**NRC Feedback on “KHNP’s Draft Revised Response to RAI 129-8085, Question 3.8.1-1”  
(Draft Response Provide 2/19/16)**

The staff evaluated the draft response to Question 3.8.1-1 and noted the following:

Figure 1. Locations for Transient Displacement (Hydrodynamic Load, Time History Analysis)

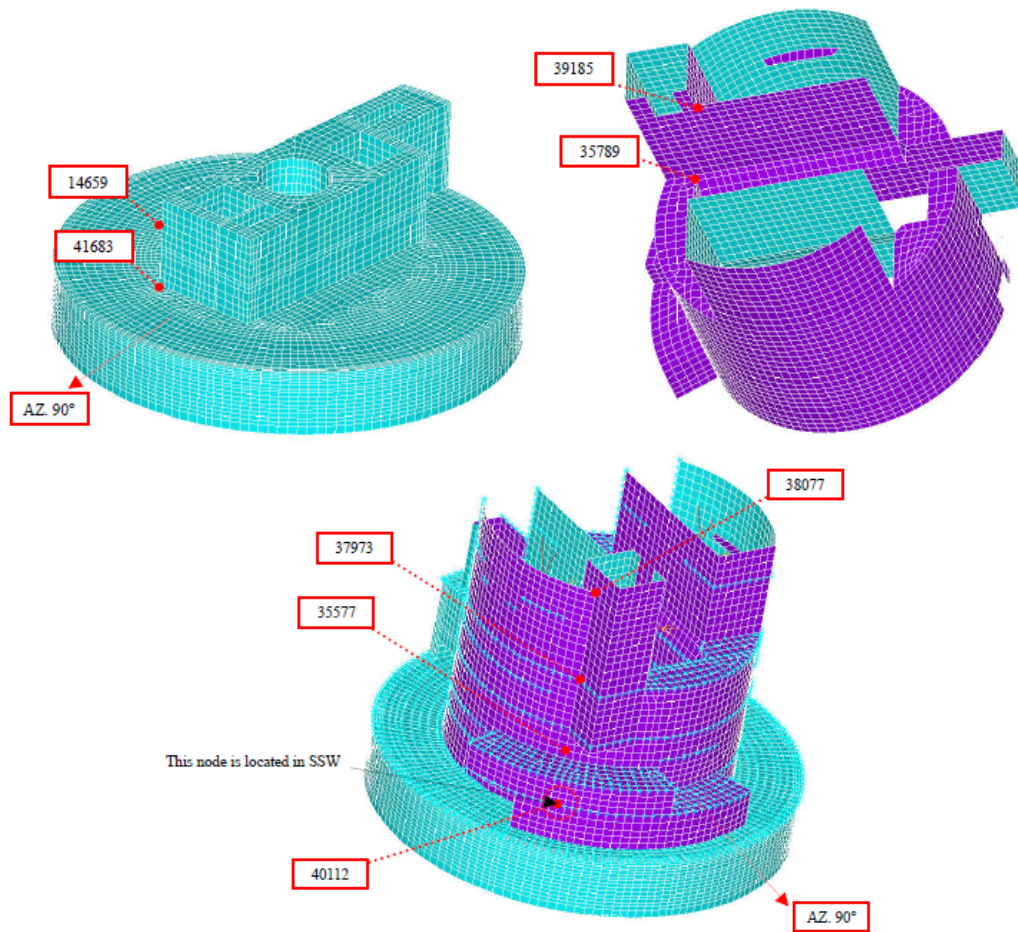
e. The first paragraph of the RAI response states “Thus, there is no connection to transfer POSRV actuation loads to the containment wall. Therefore, POSRV actuation loads are not applied to the containment basemat through the containment wall.” Since the POSRV loads also apply a pressure load on the IRWST floor slab which is on top of the RCB basemat, then POSRV loads can affect the RCB basemat directly (i.e., not through the containment wall) and also may have an effect on the dynamic overall building response in terms of member forces and building response spectra. The basis for not considering these effects should be provided or an evaluation should be performed to consider these loads.

The remaining paragraphs of the response, including the response to Question 03.08.03-1 of RAI No. 208-8245, do not adequately demonstrate that there will be no overall building response in terms of member forces and building response spectra. The RAI response indicates that the hydrodynamic pressure load is a short transient pressure time history, the period of the POSRV discharge load is very short, and the load rapidly decreases in magnitude. This type of hydrodynamic pressure time history is similar to safety relief valve transients in other nuclear power plants which have shown in some cases to cause significant loading on the overall building response and response spectra. Therefore, the applicant is requested to provide further justification to address this item.

With regard to the dynamic overall building response caused by POSRV loads, the additional hydrodynamic load analysis, which is time history analysis (refer to Table 1 of Question 03.08.01-15 of RAI No. 249-8323), has been carried out. In this analysis, the transient displacements of primary and secondary shield wall (PSW and SSW), which will be directly influenced on POSRV load because of entire structure (PSW, SSW, IRWST), were calculated. The locations for transient displacement were selected within the influence region of POSRV loading as shown in Figure 1. The maximum transient displacements of PSW and SSW are also described in Table 1. As shown in Table 1, on every direction, the maximum transient displacement is less than 0.0036 inch (0.091 mm). Figure 2 shows the Floor Response Spectrum (FRS) of PSW (EL. 100'-0", EW) by POSRV load. And the comparison of spectral acceleration between POSRV and seismic (SSE) loads (EL. 100'-0") is shown in Table 2. The spectral acceleration by POSRV is less than 9 percent of that by seismic load. Therefore, it can be judgeable that the structure response caused by POSRV load is negligible to overall building except for local design of IRWST wall for POSRV pressure load.
